ANCHOR BOLT SETTING PLAN
(BOTTOM OF BASE PLATE ELEVATION: (-1'-10") (U.N.O)
(REF:S1.1)

07/24/2020			ISSUE FOR APPROVAL
DATE	NO.		DESCRIPTION
REVISIONS

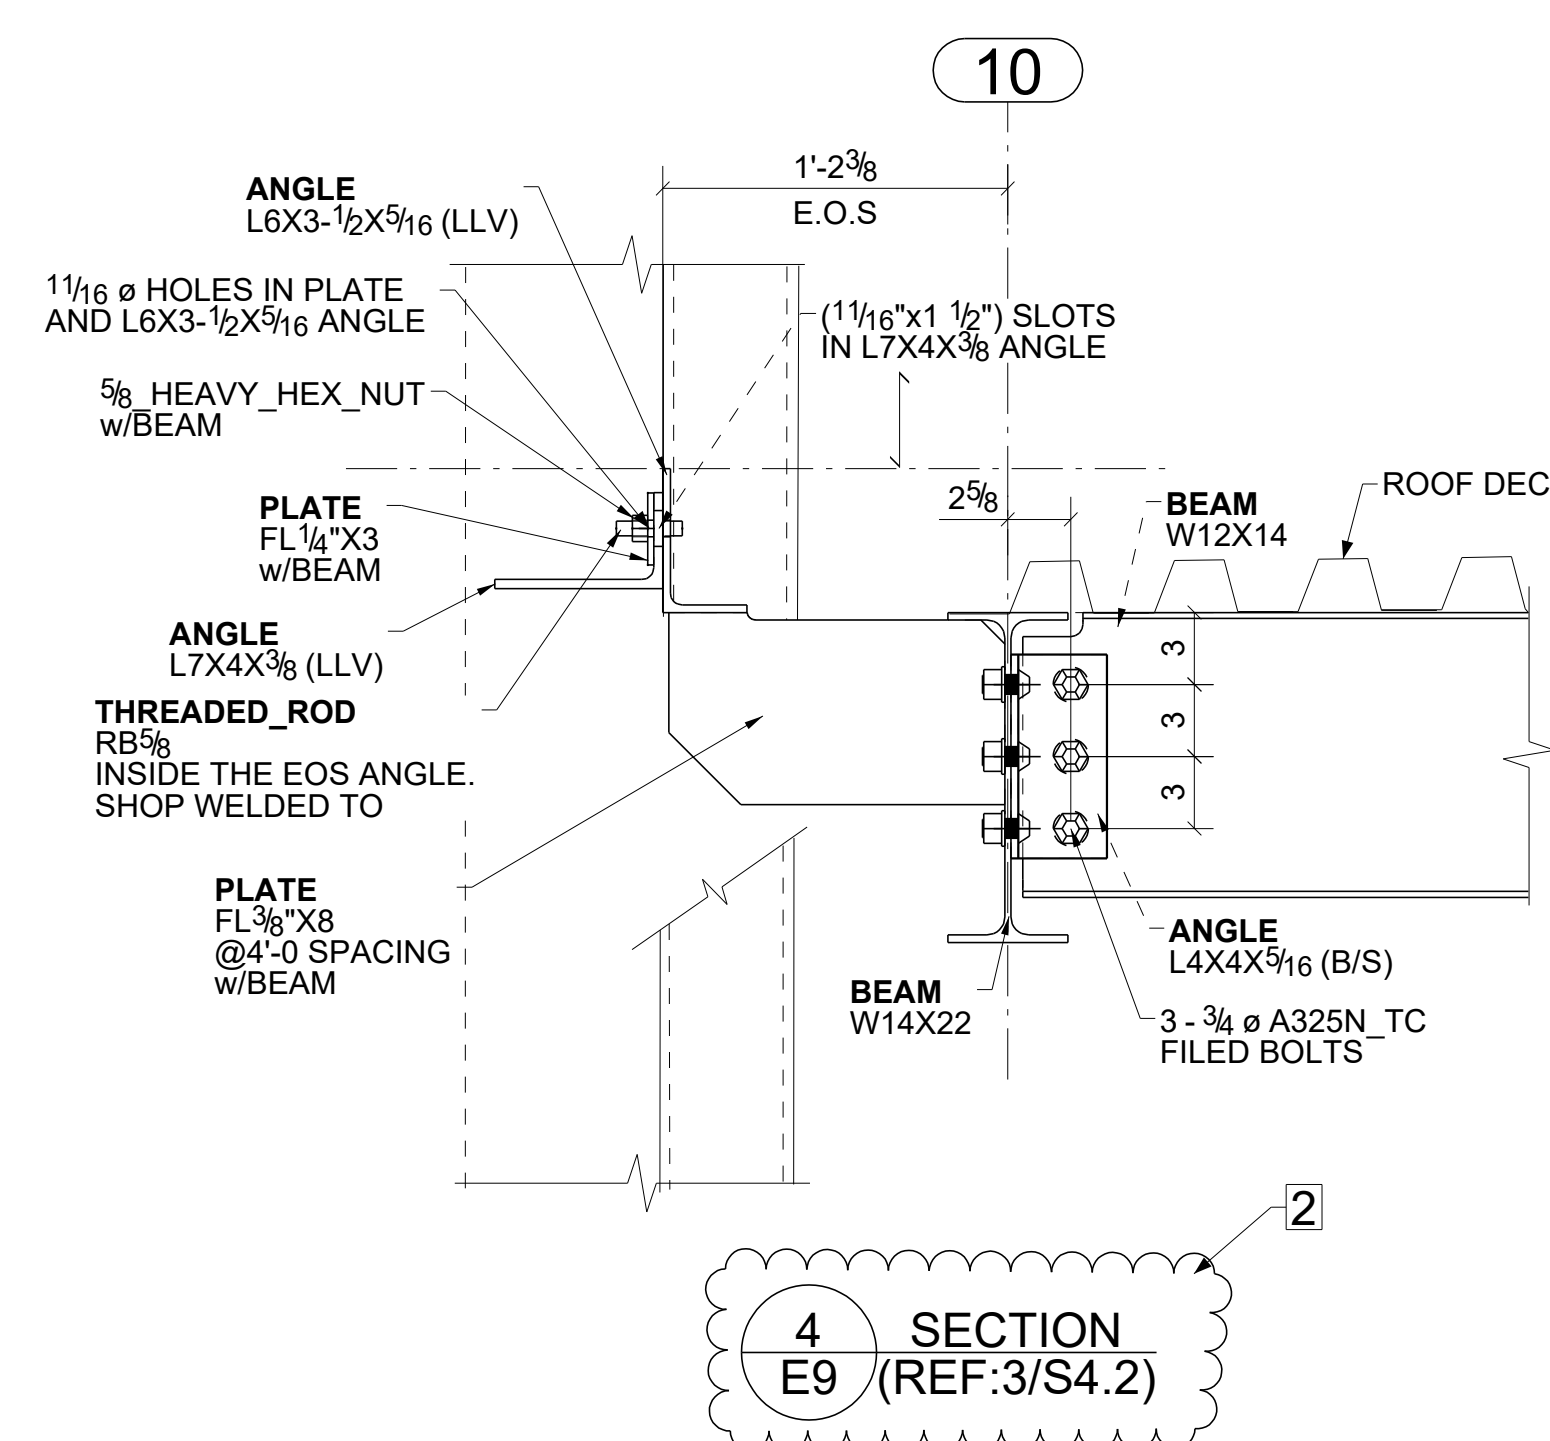
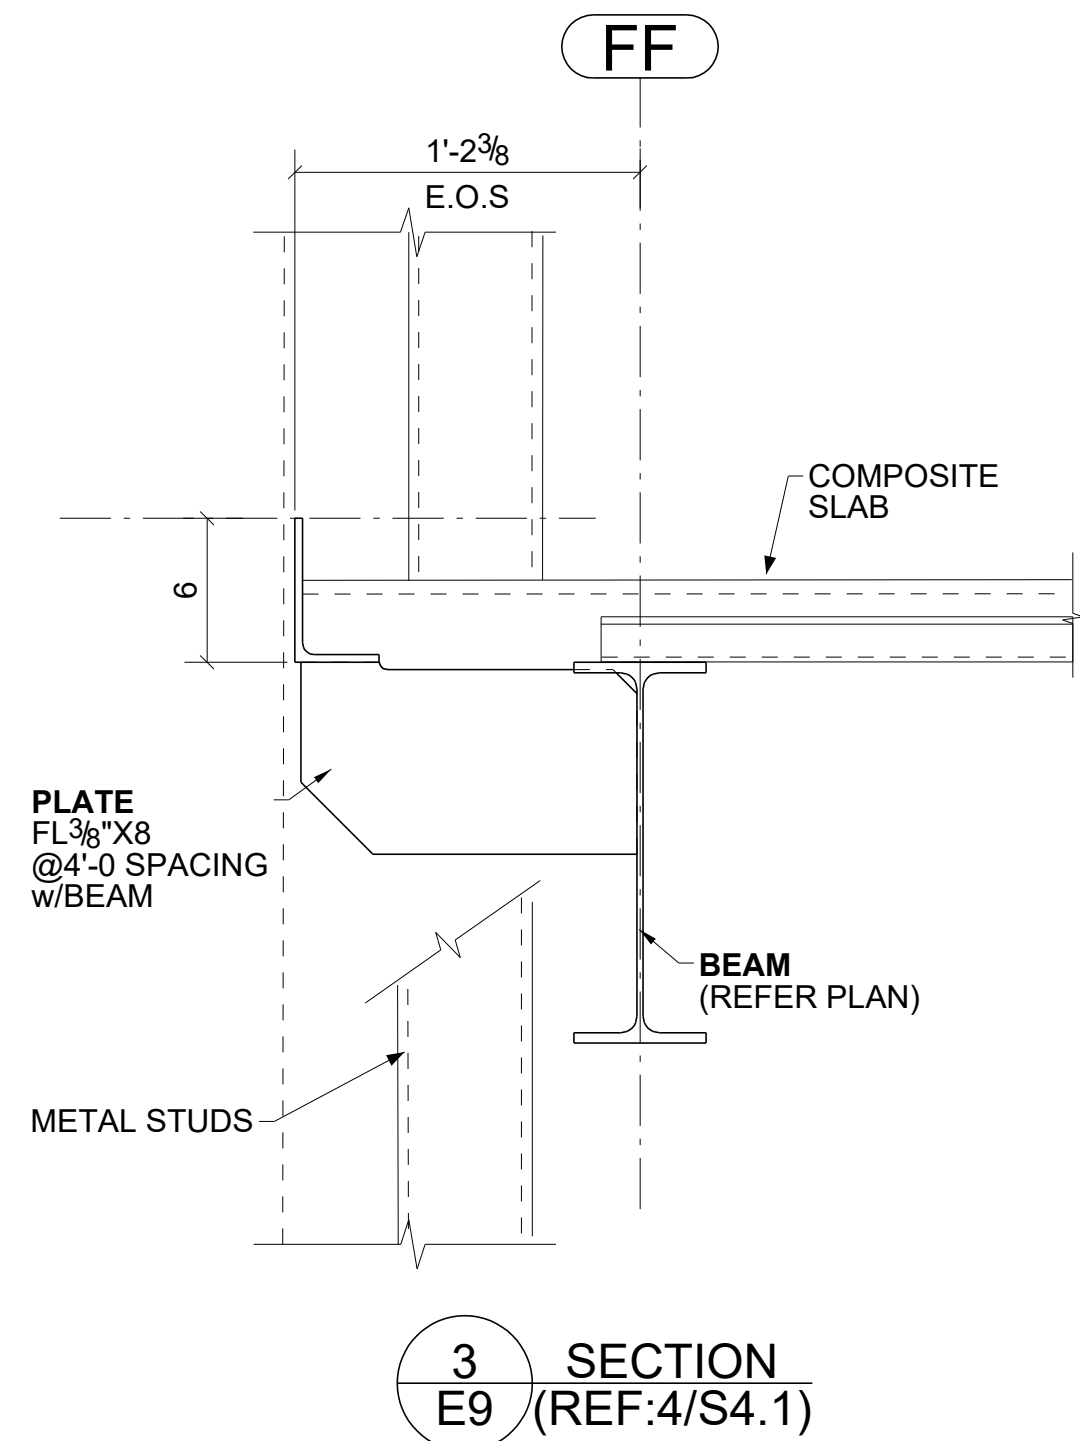
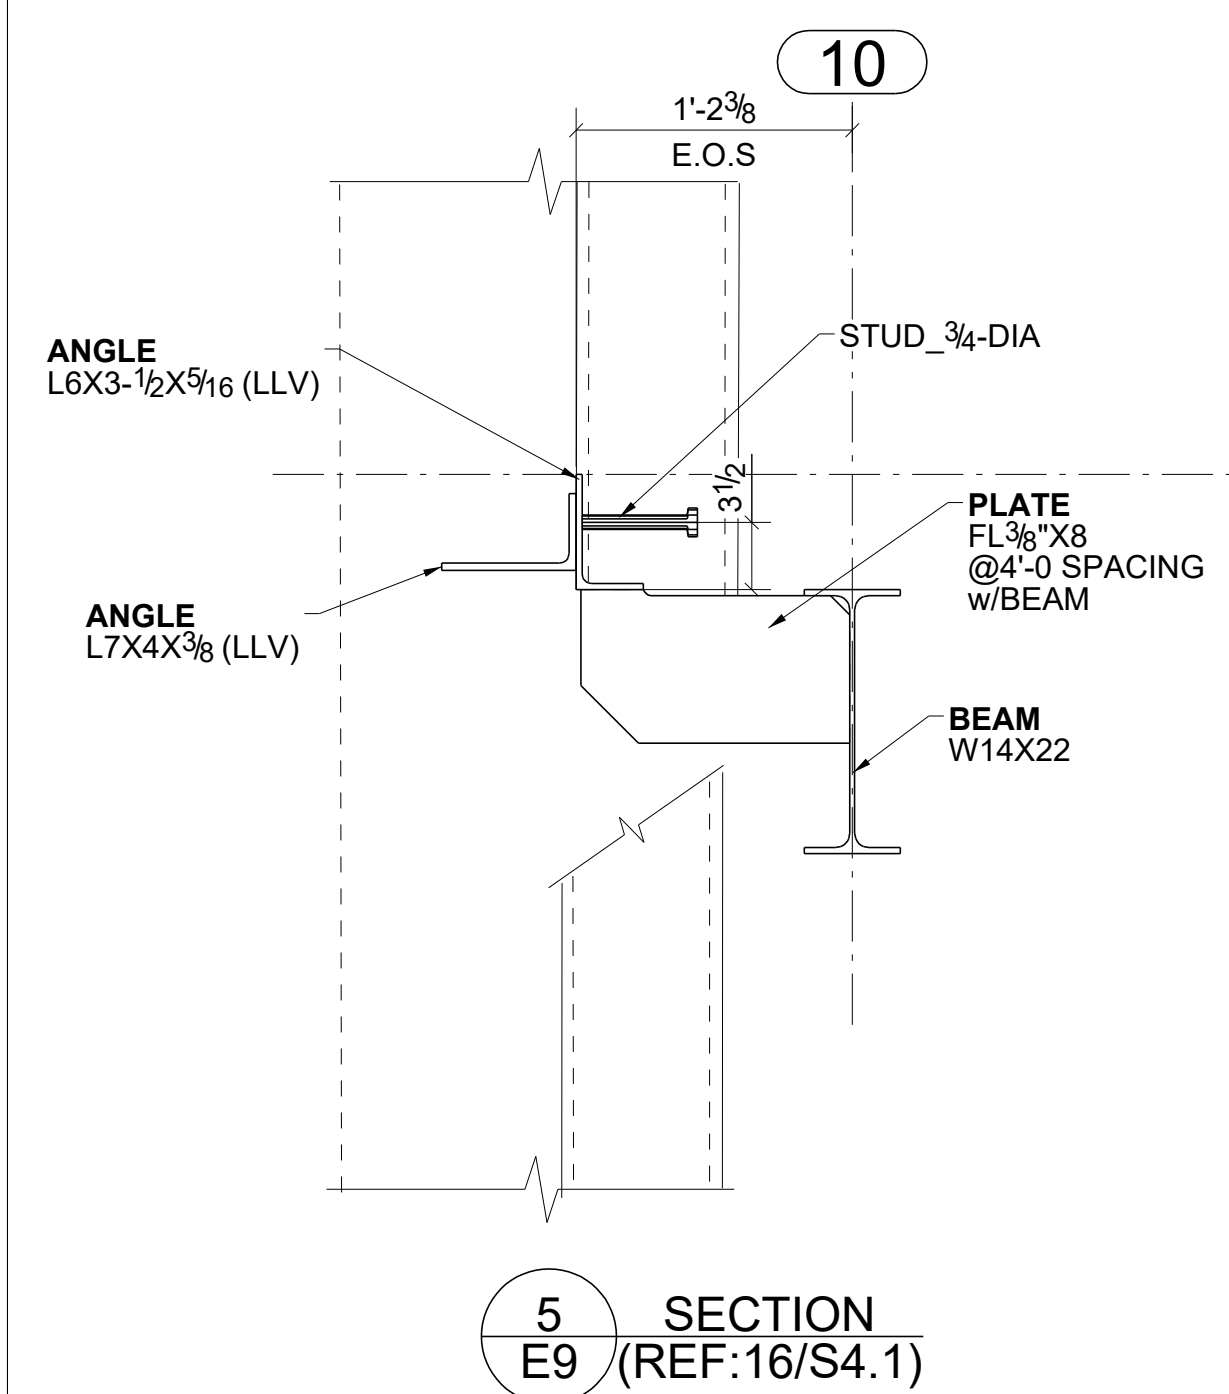
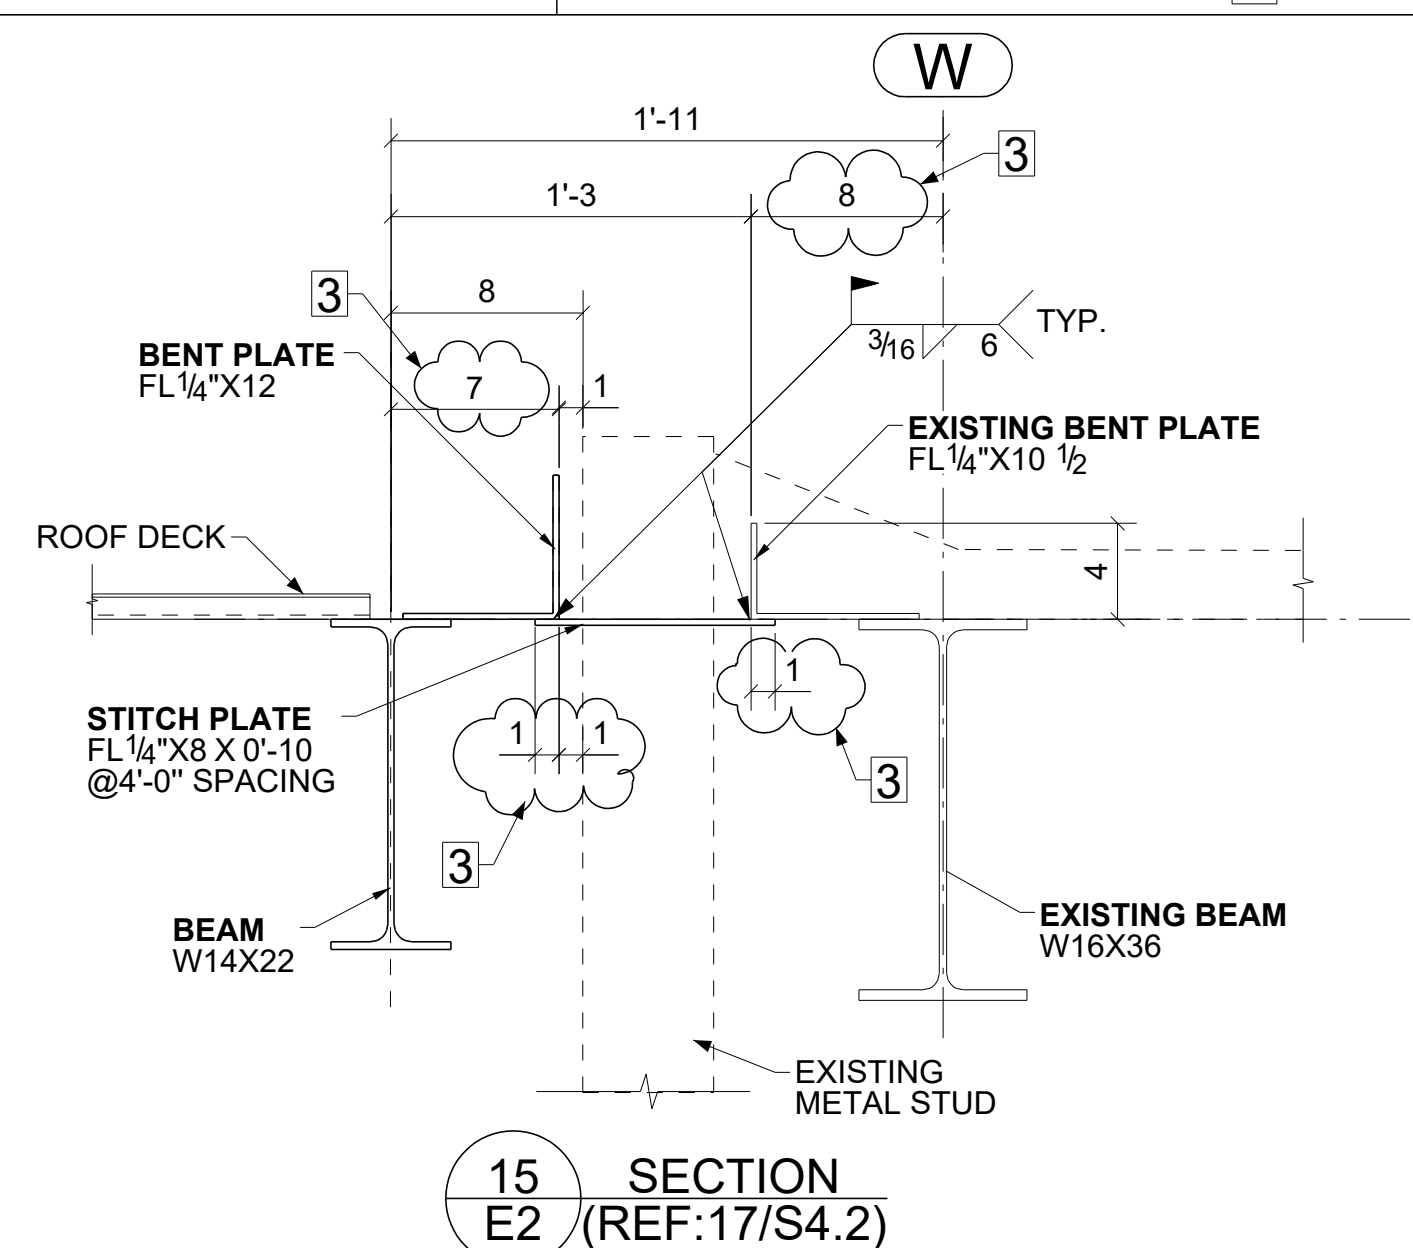
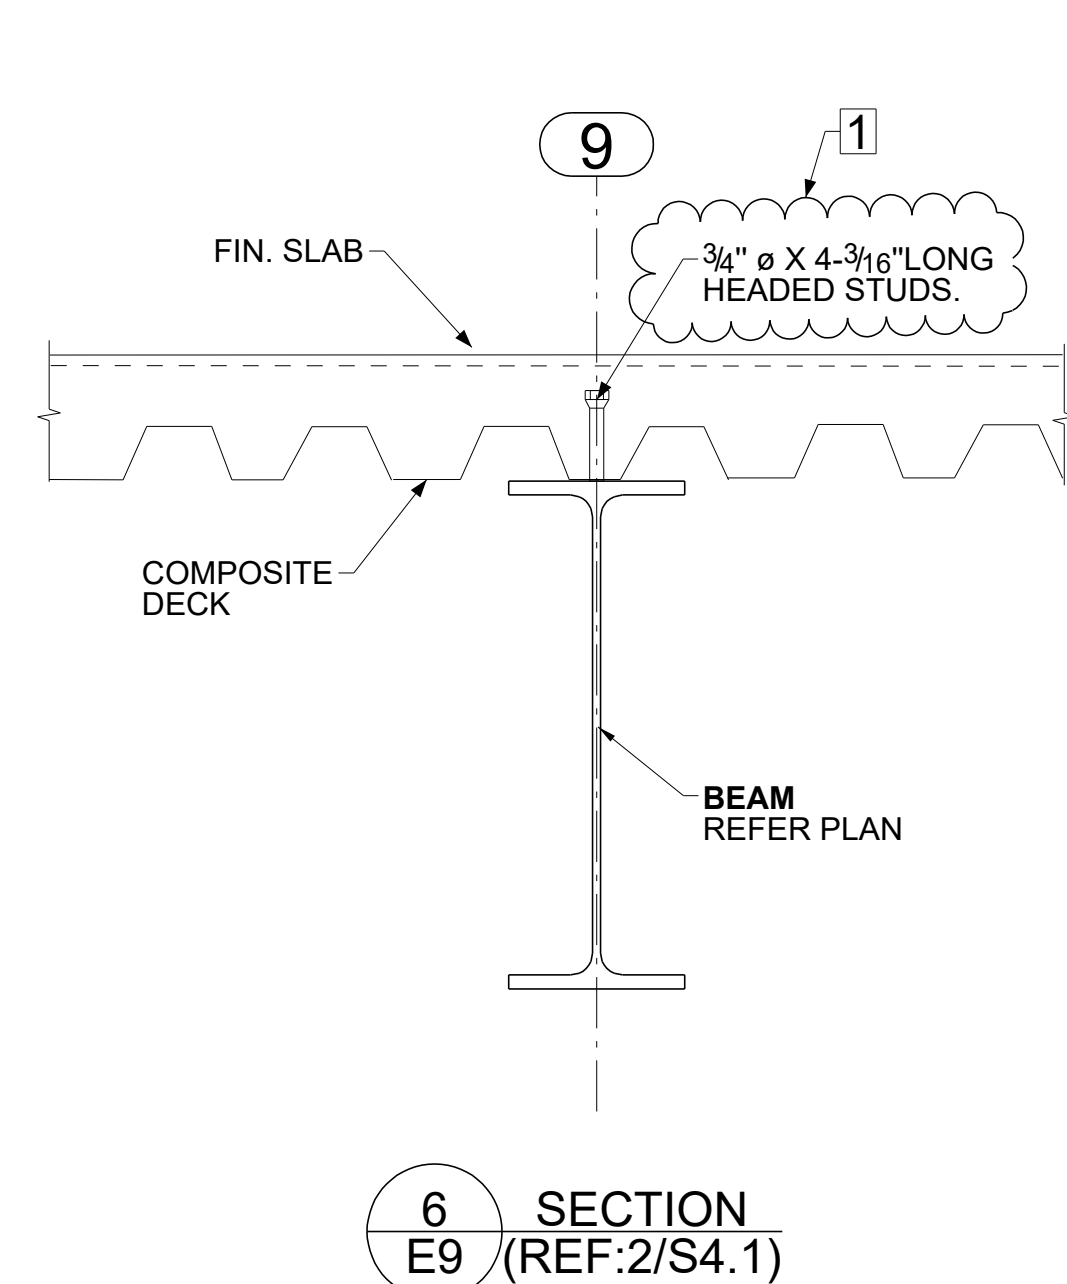
- FROM "STRUCTURAL STEEL NOTES" IN POINT-8 OF S1.0, WE ARE CONSIDERING THE STUD LENGTH AS 4 3/16" BUT THE STUD LENGTHS WILL BE AVAILABLE IN ROUND OFF'S. HENCE PLEASE ADVISE ON THE STUD LENGTH TO BE FOLLOWED.
- FOR ERECTION FEASIBILITY , WE HAVE ALTERD THE BRICK RELIEF ANGLE CONNECTION AS CLOUDED. PLEASE REVIEW AND CONFIRM.
- PLEASE REVIEW AND CONFIRM THE CLOUDED 8" EXISTING EDGE OF DECK DIMENSION AND THE STITCH PLATE FINING DIMENSIONS FOLLOWED.
- PLEASE REVIEW AND CONFIRM THE CLOUDED CONNECTIONS FOR EXISTING MARKS
